**Champlain Hudson Power Express (“CHPE”)  
Environmental Management & Construction Plan  
Notice of Major Change**

Project: Champlain Hudson Power Express

Notice Number: 276

**Segment 8 (Package 5A)  
EM&CP Appendix C Sheet Revisions**

PERMIT DRAWING NO. N/A  
 DRAWING NO. C-127  
 AS SHOWN  
 DATE: 06/09/2023

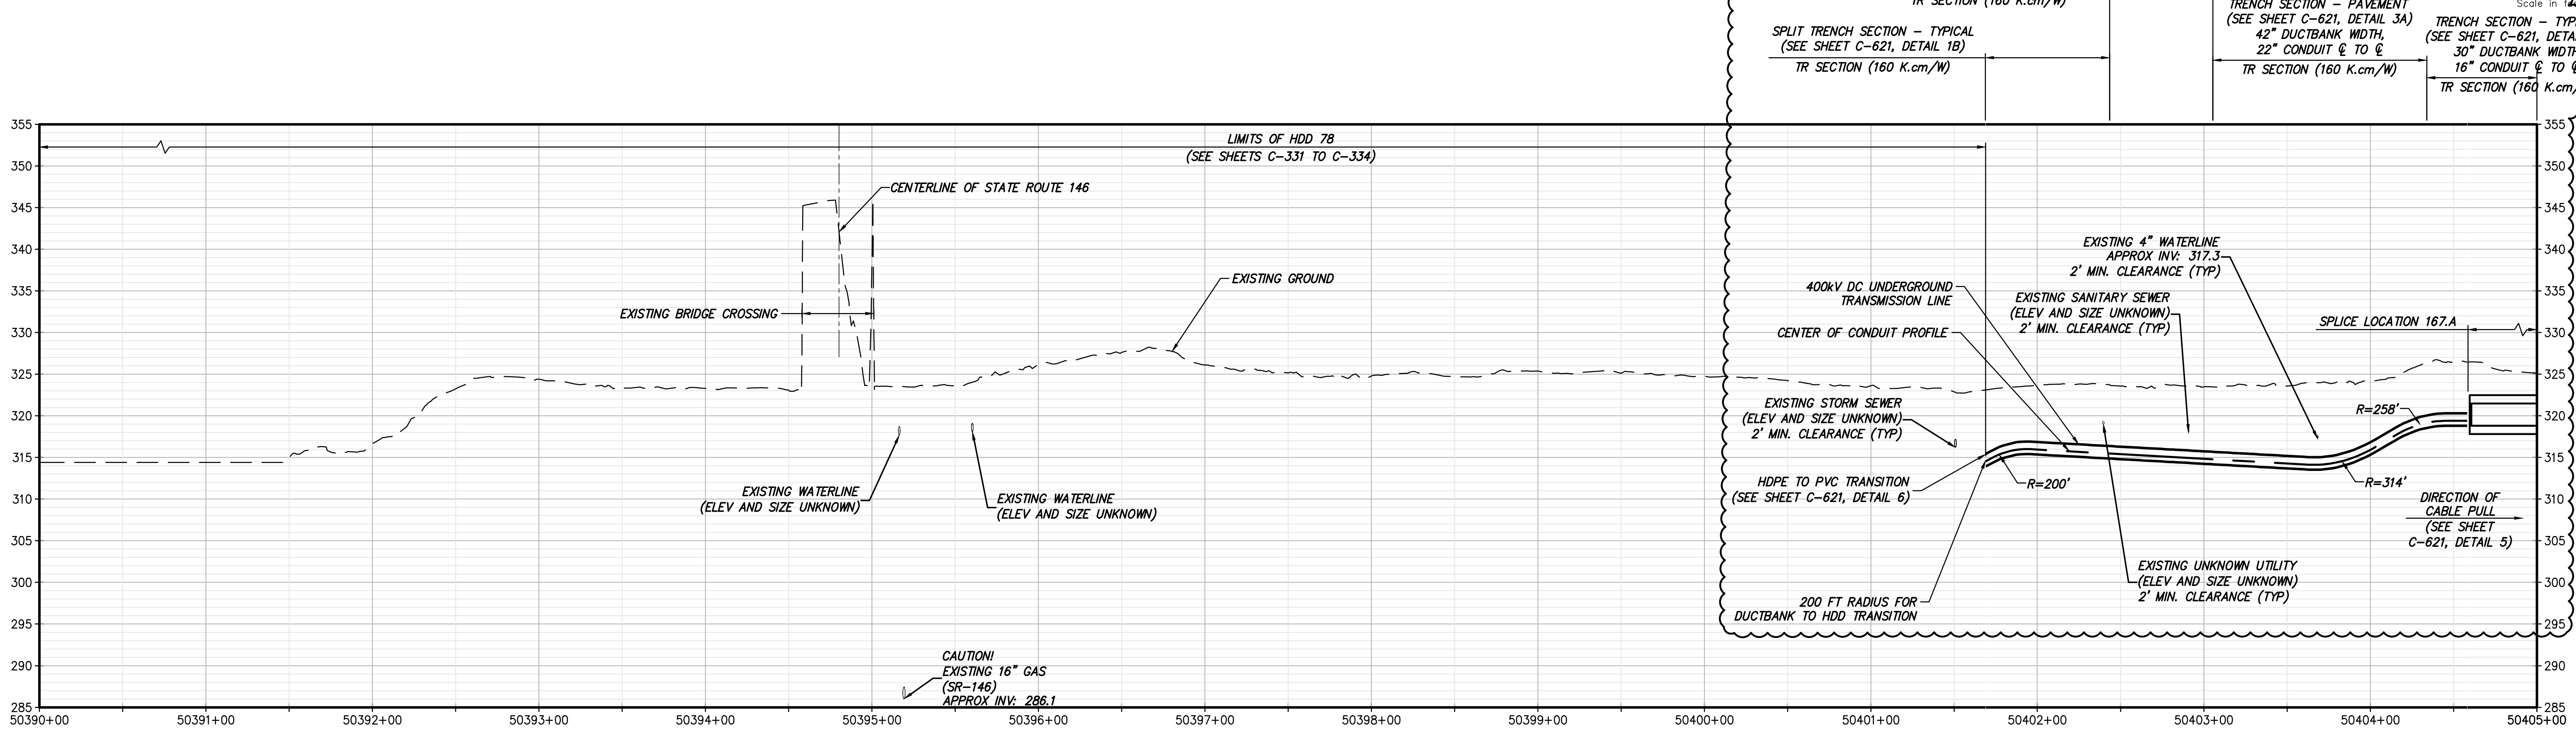
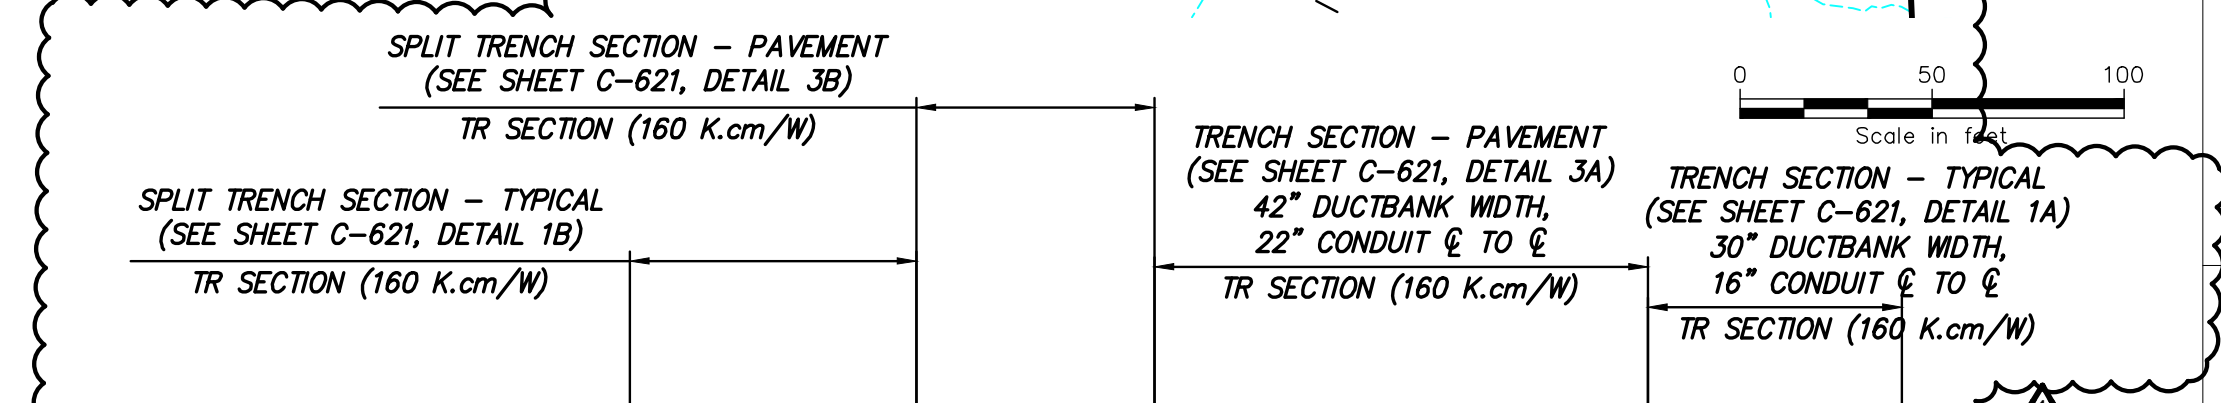
This major change involves a shift of Segment 8 (Package 5A) Splice Location 167A by approximately 30 ft to avoid a conflict with a previously unidentified existing water line running under the road. The splice is shifted out of the road and into a green space just south of the parking lot based on coordination with the Landowner. The duct bank alignment on either end of the splice from ~STA 50402+00 to ~ STA 50409+50 was adjusted based on the revised splice location.

<b>Sheet No.</b>	<b>Rev No.</b>	<b>Revision Description</b>	<b>Summary</b>
C-127	2	NDC-0129: Guilderland Fire Center Splice 167A	Update plan and profile to incorporate revised splice 167A location, associated duct bank alignment shift, and utility updates based on field locates.
C-128	3	NDC-0129: Guilderland Fire Center Splice 167A	Update plan and profile to incorporate revised splice 167A location, associated duct bank alignment shift, and utility updates based on field locates.
C-414	2	NDC-0129: Guilderland Fire Center Splice 167A	Update to erosion and sediment control plan to reflect splice and alignment changes

*Deviation Zone Analysis*

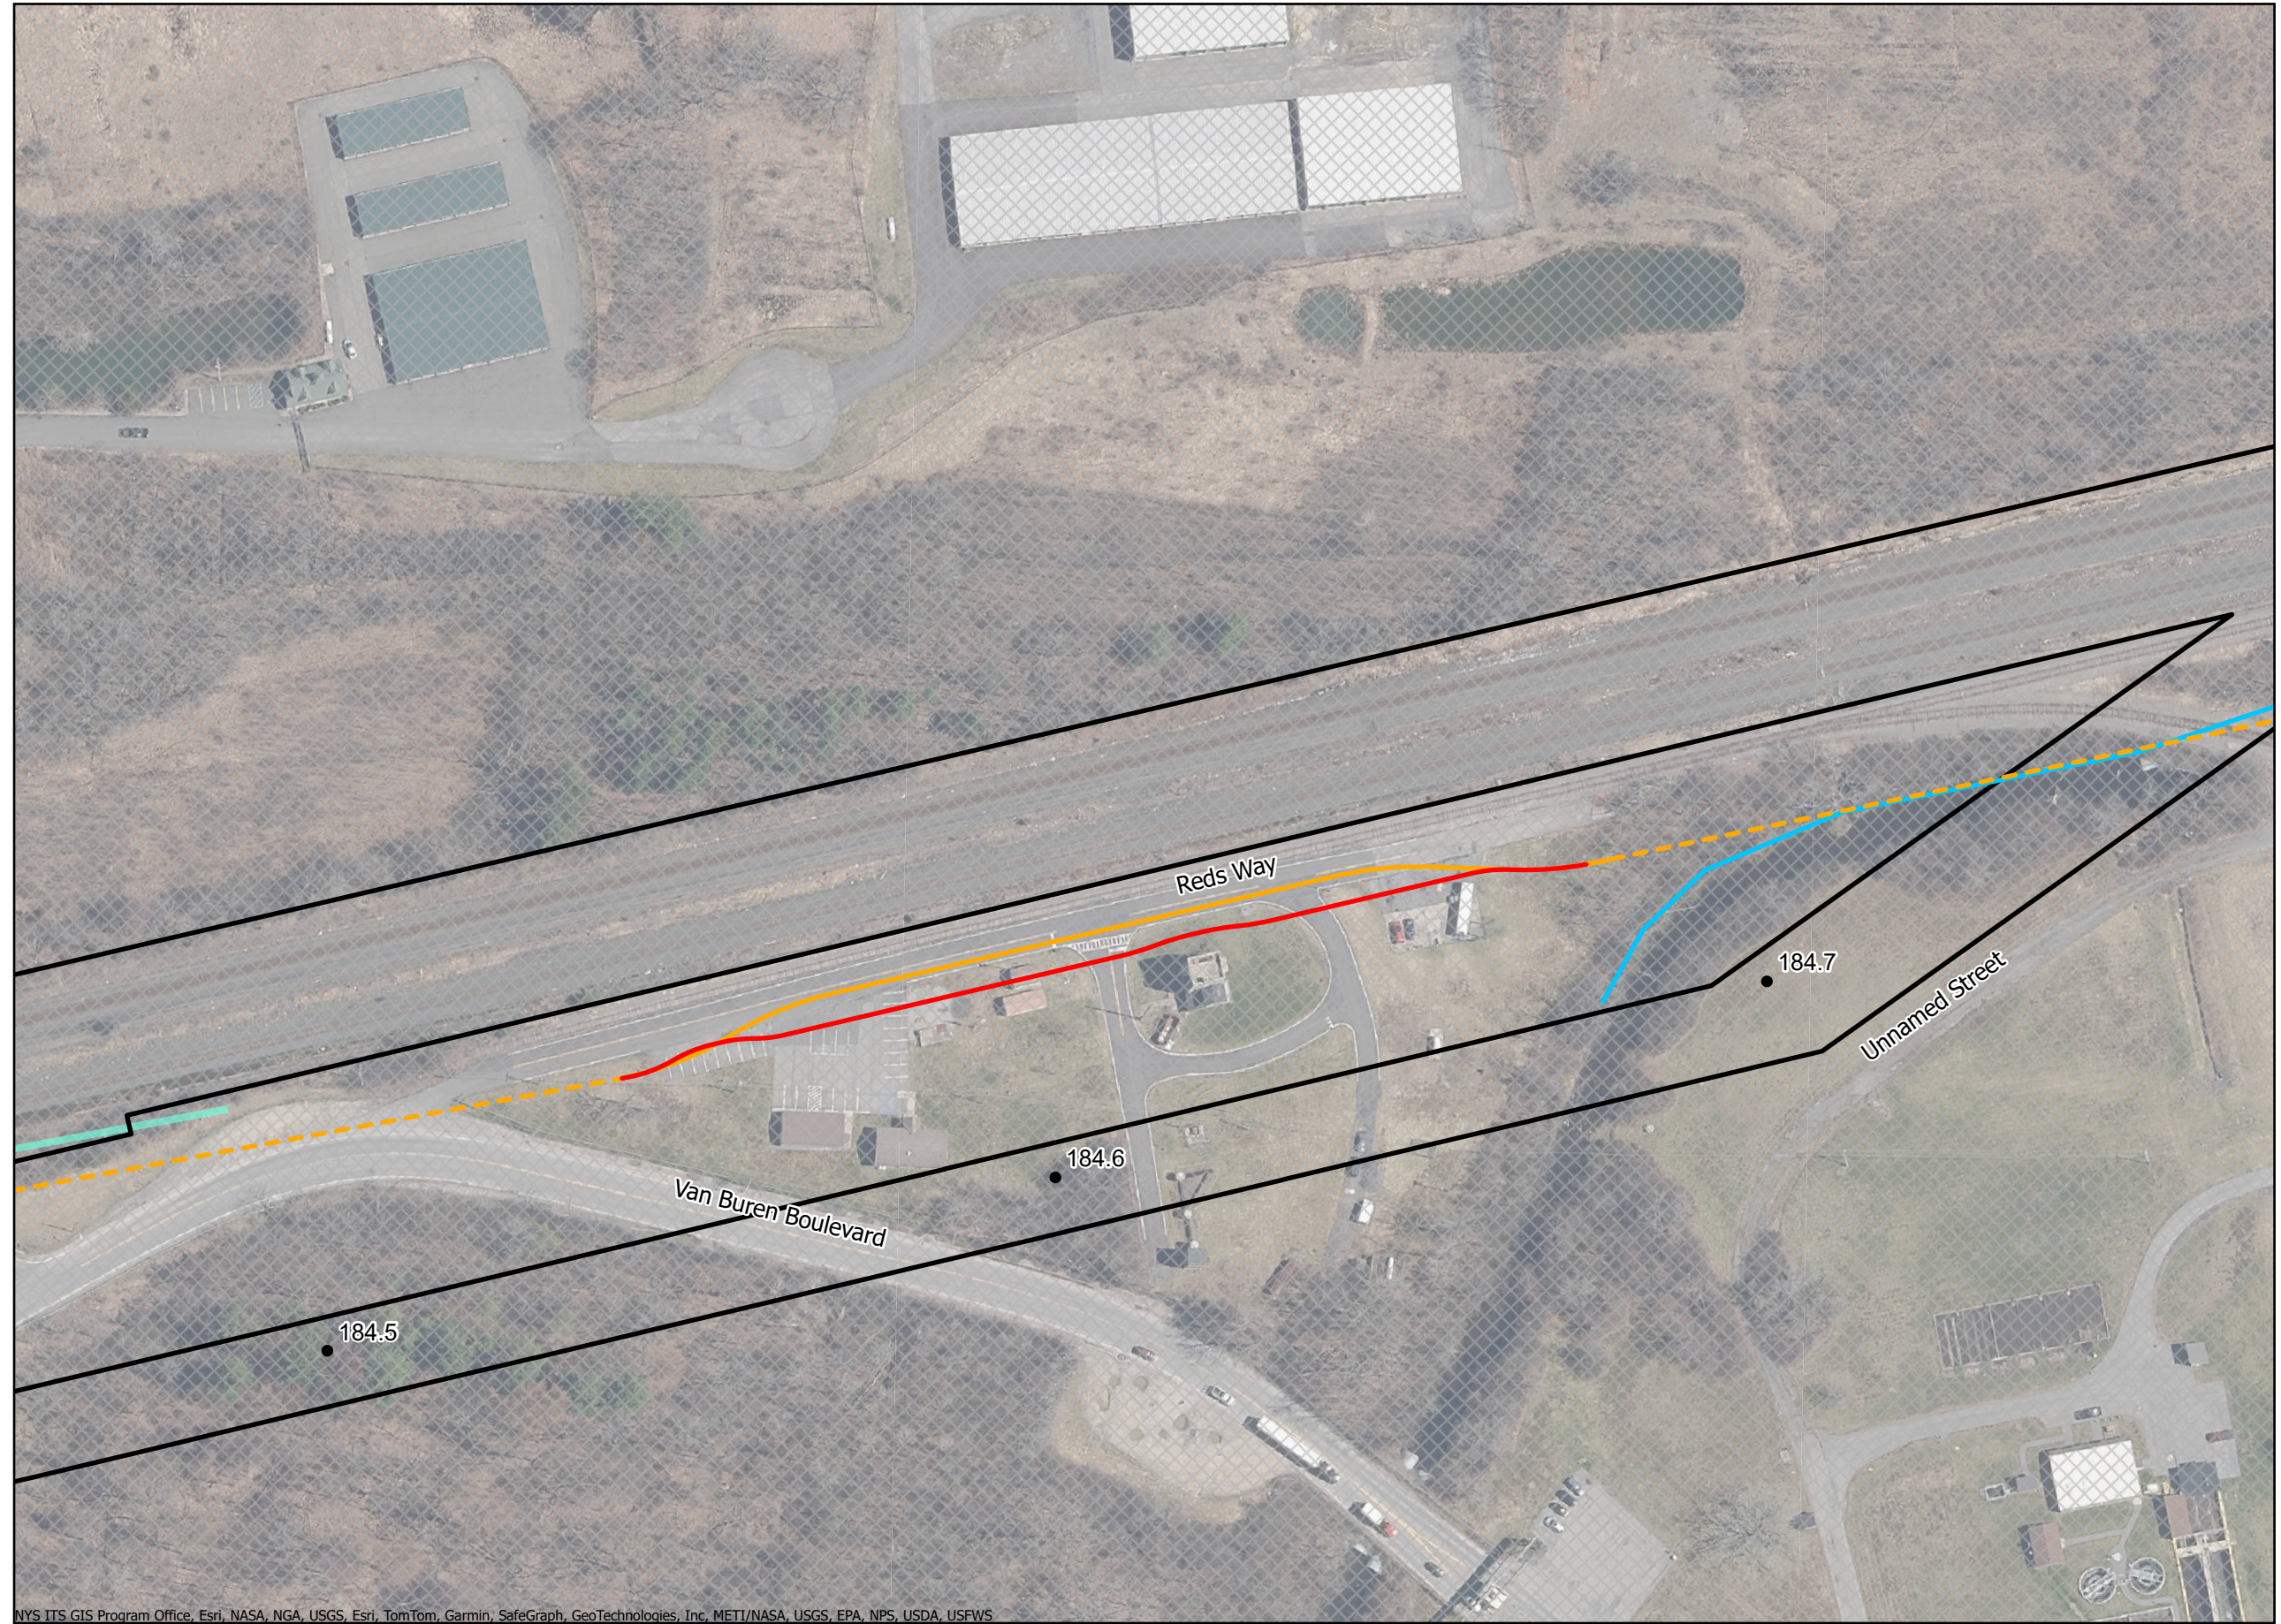
There are no revisions to the existing Segment 8 (Package 5A) excursion table with this change. This alignment shift occurs entirely within existing excursion S8-14. There are no changes to the environmental impacts associated with this excursion. An updated excursion GIS exhibit is included for reference.
